Oakdale Irrigation District – Metal Building Bid
Package 2.1
1110 Kaufman Road, Oakdale, CA

TETER Project No.: A 18-10850 D

ADDENDUM NO. 2

PROJECT NO.
18-10850
 DRAWING
P001

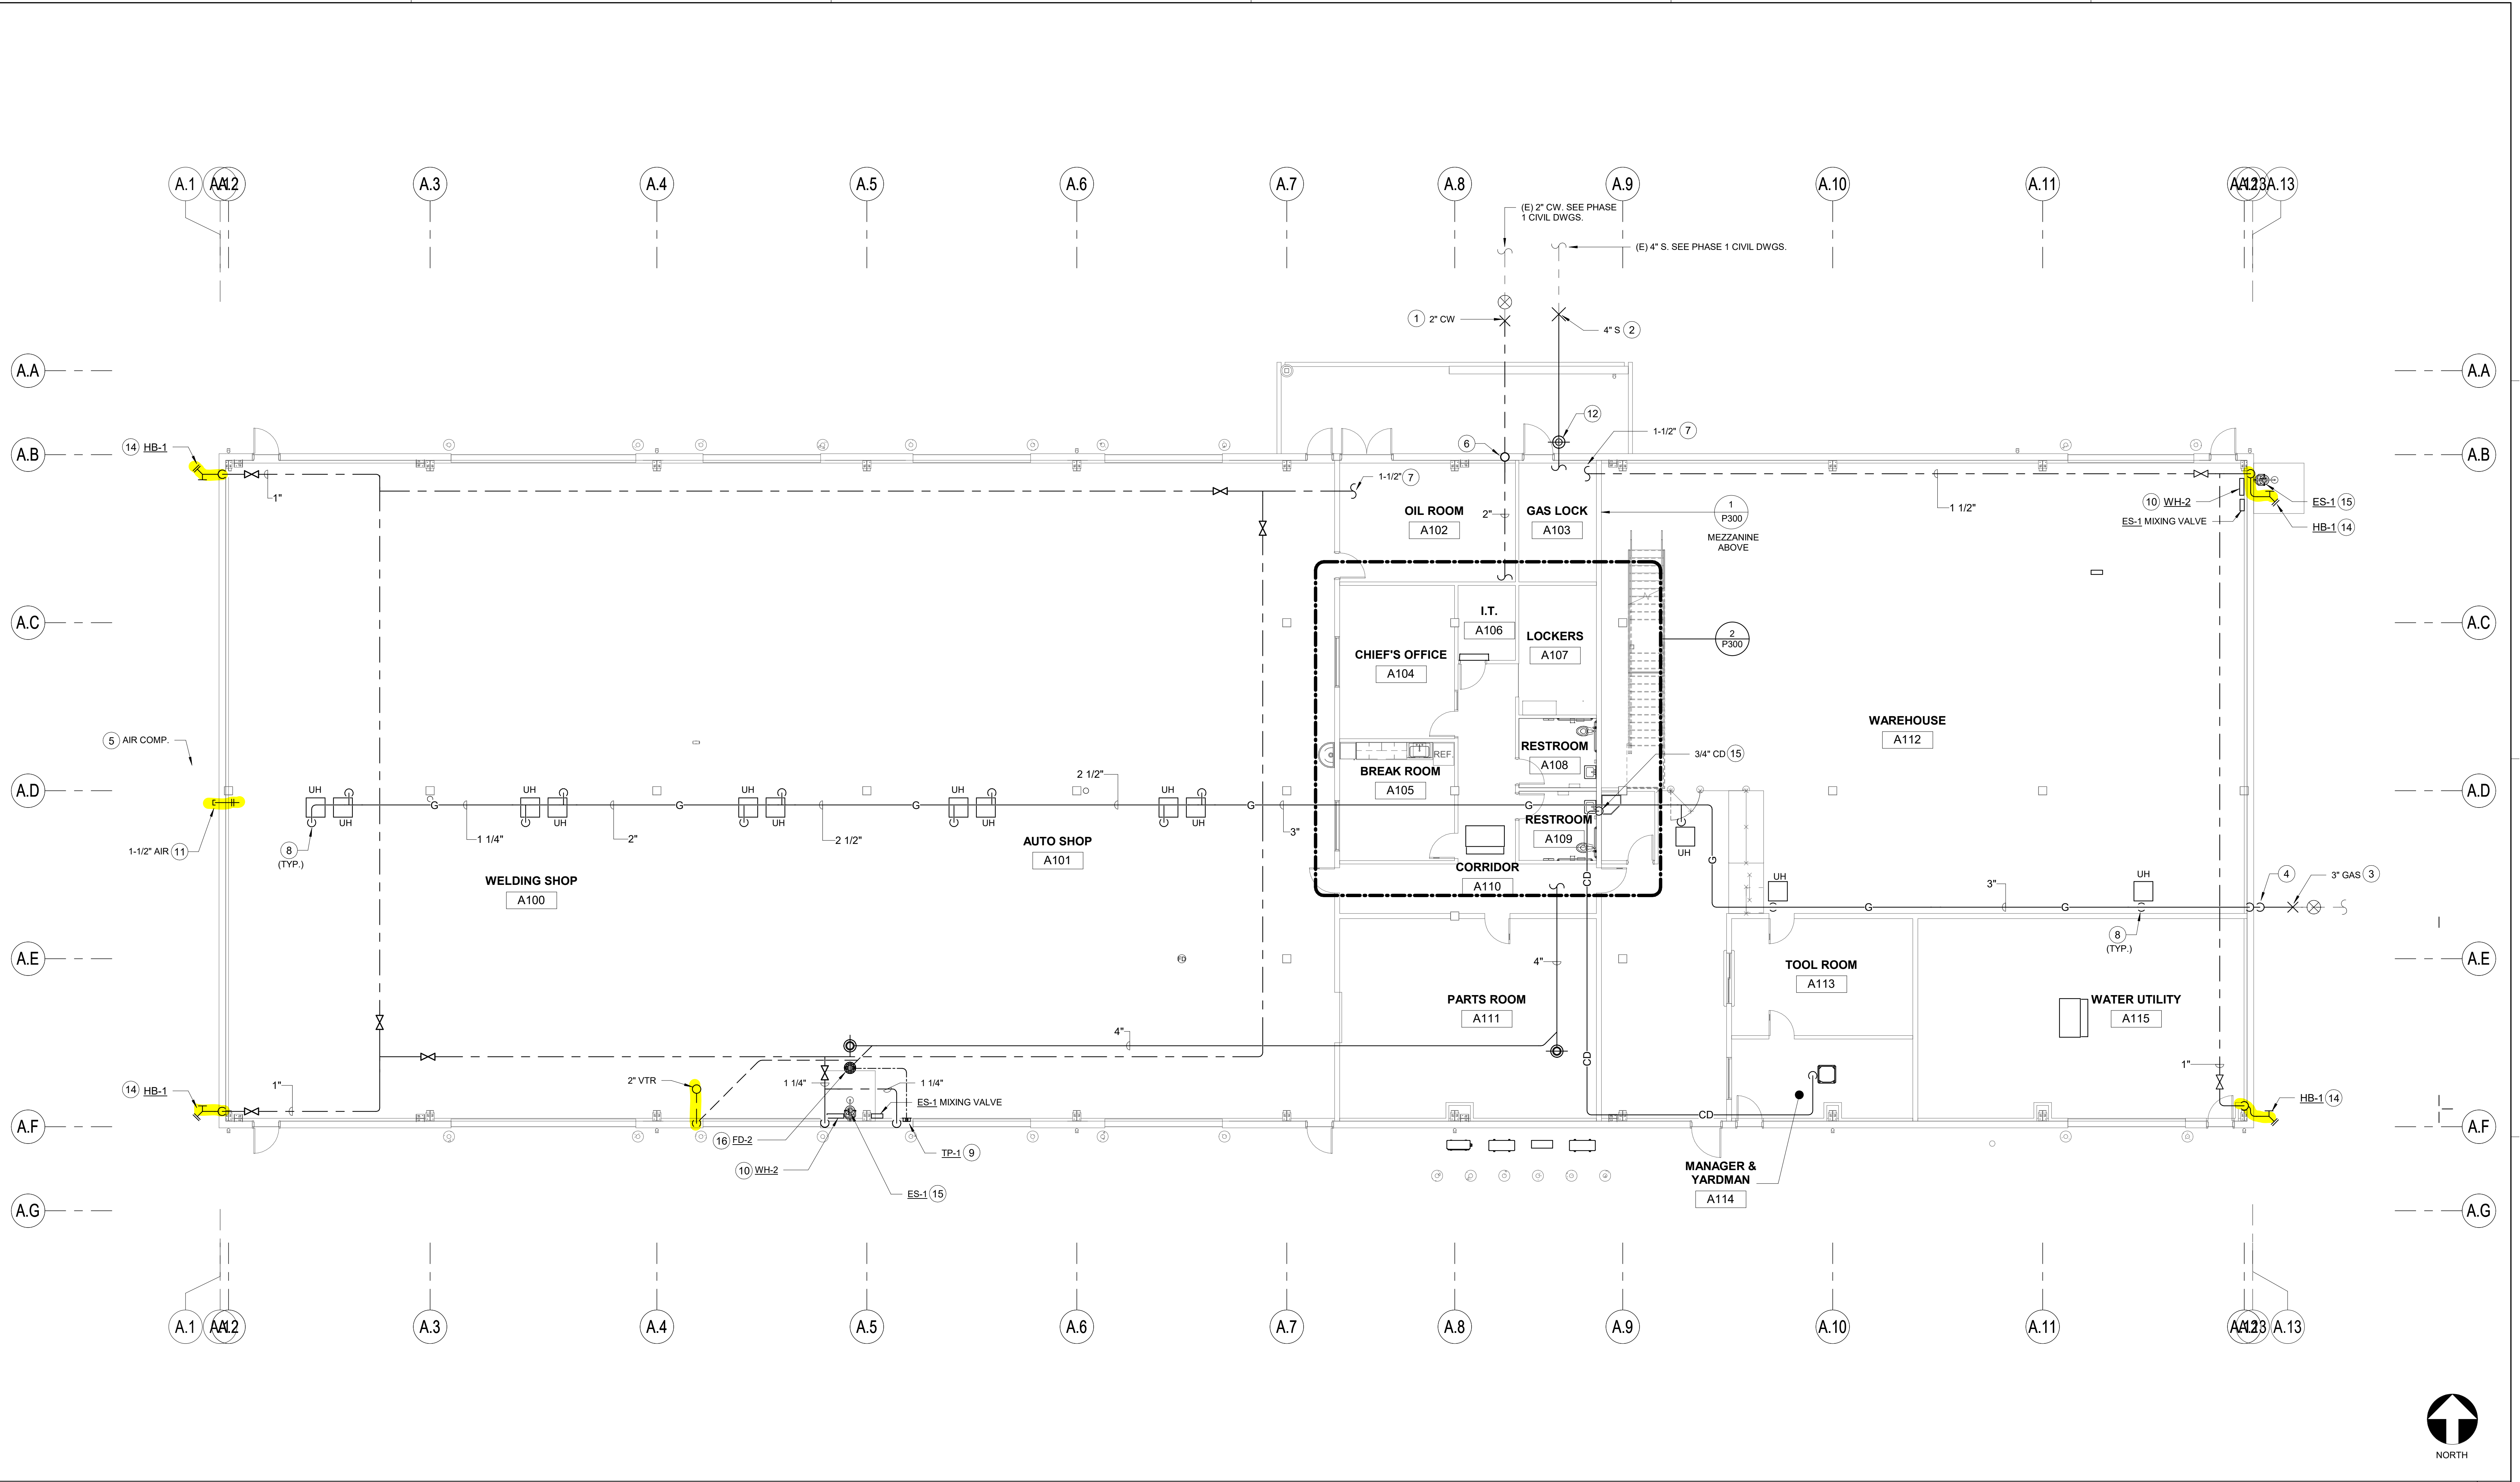
- A. Specifications Section 2.10 list accessories ridge ventilators, louvers, roof curbs, pipe flashings. Need location and information.

Response: Refer to Supplemental Drawings SD-P01 thru SD-P03 and SD-M01 thru SD-M02 for locations of proposed mechanical and plumbing elements associated with the metal building exterior walls/roof.
